## Appendix 4: Stakeholder consultation

### Consultation during the development of this plan

## Changes made to this plan following consultation

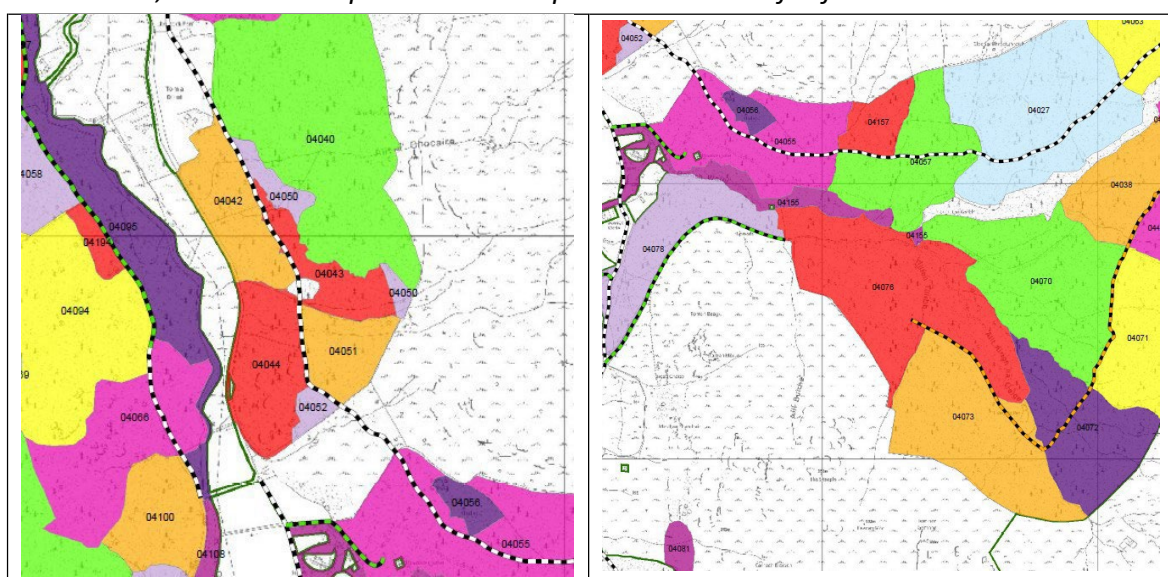
*Figures 1a (left) & 1b (right) – In the consultation version of this plan, shown here, coupes 04042 and 04044 (orange and red coupes in the left-centre of Fig. 1a) were to be felled over two felling phases; these coupes will now be combined and felled as one coupe, 04044. Coupe 04076 (red coupe in the centre of Fig. 1b) was to be felled in this plan period in the consultation version shown here; this has been pushed back to phase 2. See text for further details.*

**Strath Gail East:** Roadside coupe 04044 in this plan, this was presented as 04042 and 04044 in the Consultation version with felling phases of Ph1 (04044) and Ph2 (04042) which was in line

with the previous plan. This focused on the area where Larch spp. are concentrated, mainly in the southern area. It is acknowledged after internal discussion that the break between these coupes, following a burn, is not clear enough to provide a green edge that we can be confident would be windfirm; this is not an acceptable risk given this coupe's proximity to the only public road in and out of Lochgoilhead village and Carrick Castle. Hence this will be felled as one coupe (ref. Figure 1a and Map M04 Felling and Thinning).

**Donich Glen:** Coupe 04076 has been pushed back into Phase 2 (i.e. outwith the approval period of this plan). Access to this coupe relies on the planned road being built in Donich Glen. This is not planned until 2026/27 for budgetary planning reasons which means that it may not be possible to clearfell it in the plan period. In the event of an SPHN being served in this area before the road is built, alternative solutions for Larch felling and SPHN compliance may be required (ref. Figure 1b).
